Rezoning Transportation Analysis

Petition Number: 2017-118

General Location Identifier: 04115106

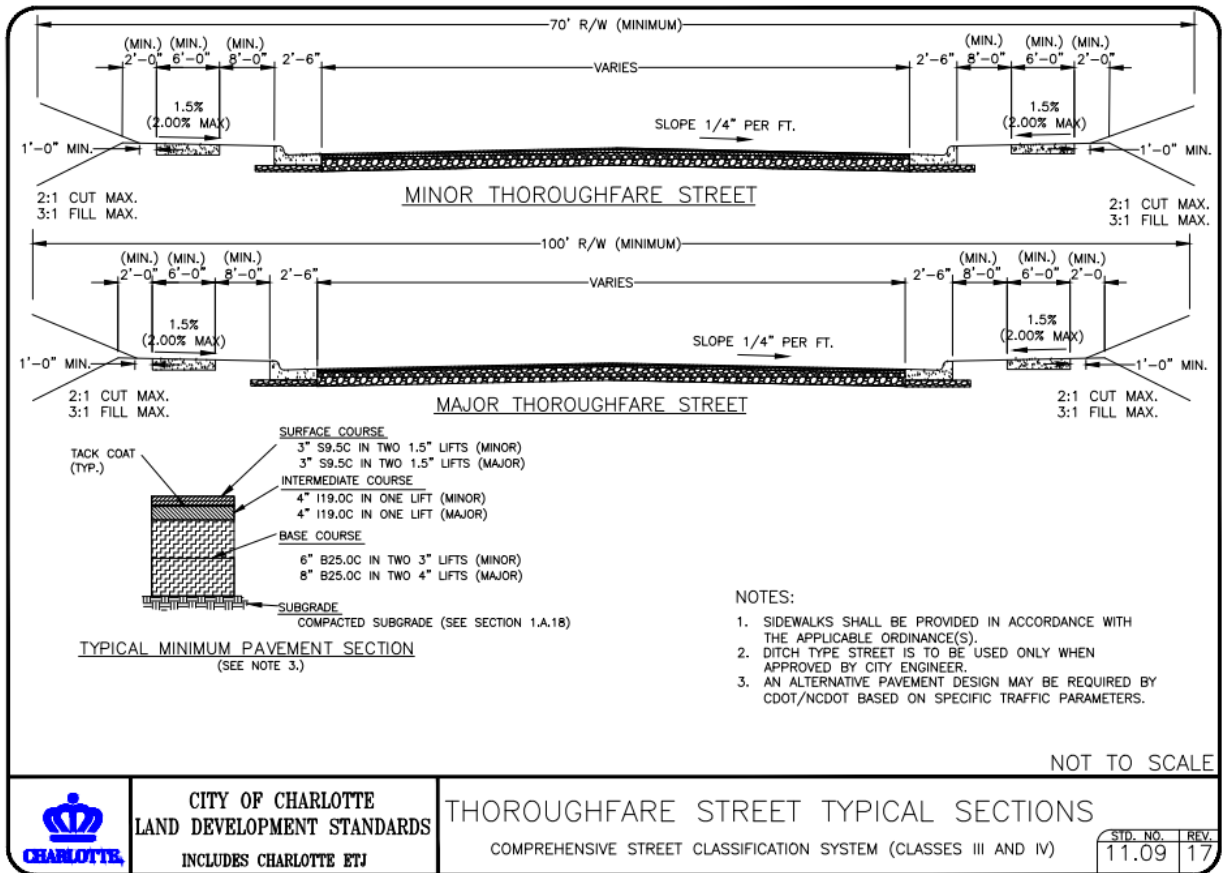
2. ~~**Outstanding Comment (site plan dated 05/11/20)** The petitioner should revise the site plan to show the driveway on Statesville pushed back away from the signalized intersection as far as possible and would need to be reconstructed as a Type II Modified Driveway during permitting. CDOT would like to see closure of Cindy Lane driveway if possible.~~

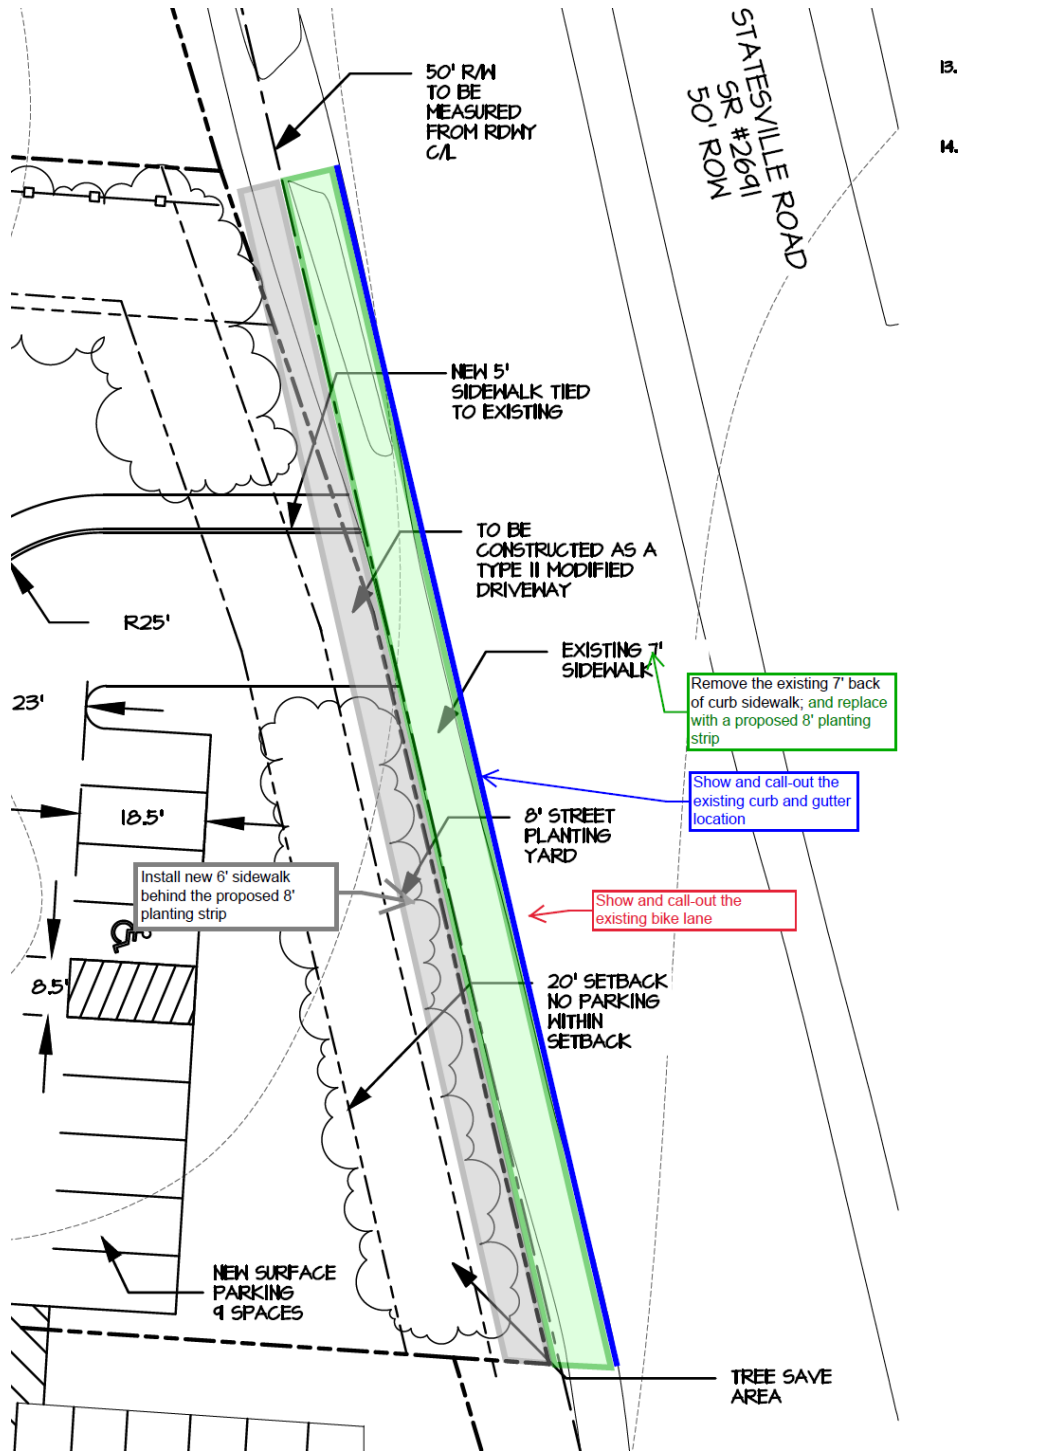
3. ~~**Outstanding Comment (site plan dated 05/11/20)** If large trees are removed, the petitioner should reconstruct to an 8' planting strip and 6' sidewalk along frontage, as required by Chapter 19 of the City Code. The proposed planting strip must be a minimum of 8' in width. The 6' sidewalk may meander around the existing trees, if contained within a sidewalk utility easement, which is to be placed 2' from the proposed back of sidewalk. The planting strip must be installed between the existing back of curb and proposed sidewalk. Refer to the additional design references provided below.~~

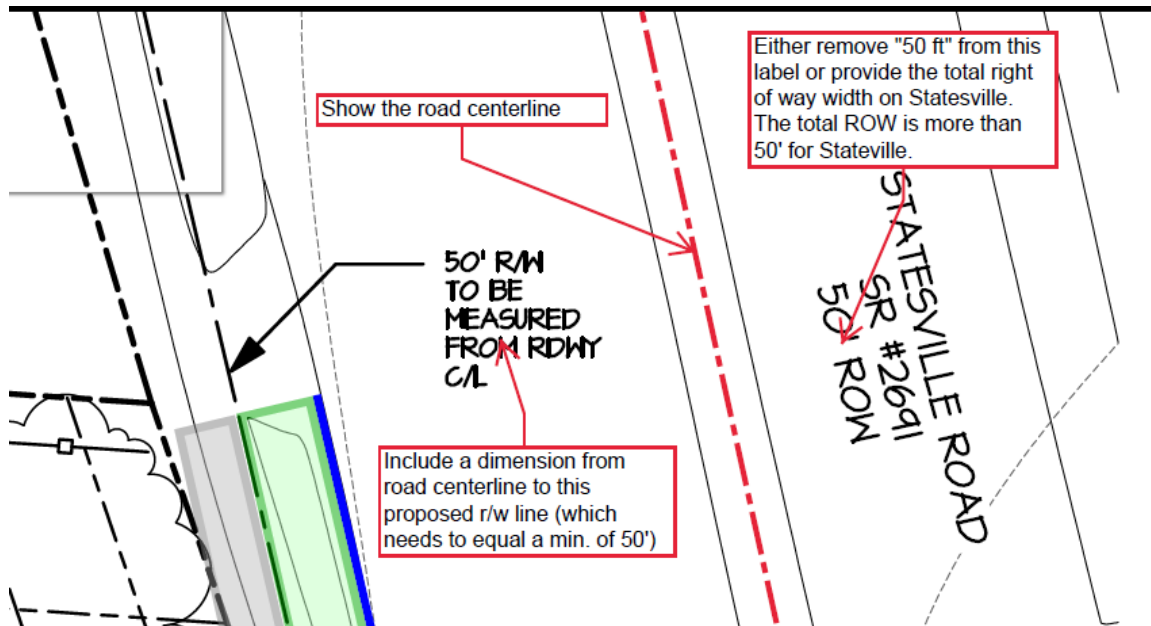
4. ~~Outstanding Comment (site plan dated 05/11/20)~~ Revise the site plan to dimension the proposed right of way dedication from the Statesville Road centerline. Additional design guidance is provided below.
